From: Andrew Leon
Sent time: 2022/10/05 05:18:46 PM
To: Jackie <jackie@mediciarchitects.com>
Cc: Schuyler Tutt <schuyler@mediciarchitects.com>
Subject: RE: PRE22-038: 2430 74th Ave SE
Attachments: image001.png

From: Jackie <jackie@mediciarchitects.com>
Sent: Wednesday, October 5, 2022 2:54 PM
To: Andrew Leon <andrew.leon@mercerisland.gov>
Cc: Schuyler Tutt <schuyler@mediciarchitects.com>
Subject: PRE22-038: 2430 74th Ave SE

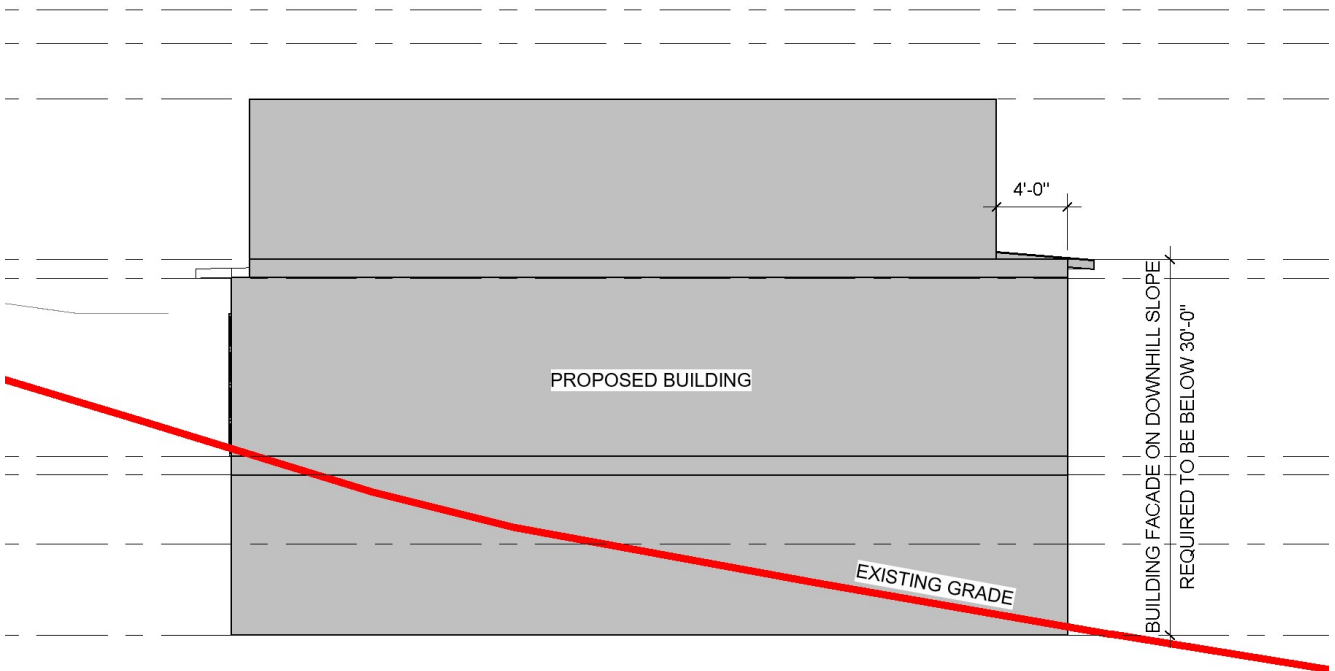
This is Jackie with Medici Architects, and I just had a follow up question regarding the building height requirements on the downhill side of the building. Section 19.02.020.E.2 requires that the maximum building façade height on the downhill side of a sloping lot shall not exceed 30 feet in height. The building façade height shall be measured from the existing grade or finished grade, whichever is lower, at the furthest downhill extent of the proposed building, to the top of the exterior wall façade supporting the roof framing, rafters, trusses, etc.

We are proposing a setback of the building in order to follow the topography of the site and would like to confirm that our intent is correct. Below is a diagram depicting the setback and conforming façade height.

MICC 19.16.010 defines façade as any exterior wall of a structure, including projections from and attachments to the wall. Projections and attachments include balconies, decks, porches, chimneys, unenclosed corridors, and similar projections. MICC 19.02.020(E)(2) does not contemplate multiple building facades or exterior wall facades on the downhill side of a sloping lot, only the maximum building façade height as a single exterior wall supporting the roof. As such, the downhill façade for the diagram you provided in your email would include all three floors of the house.
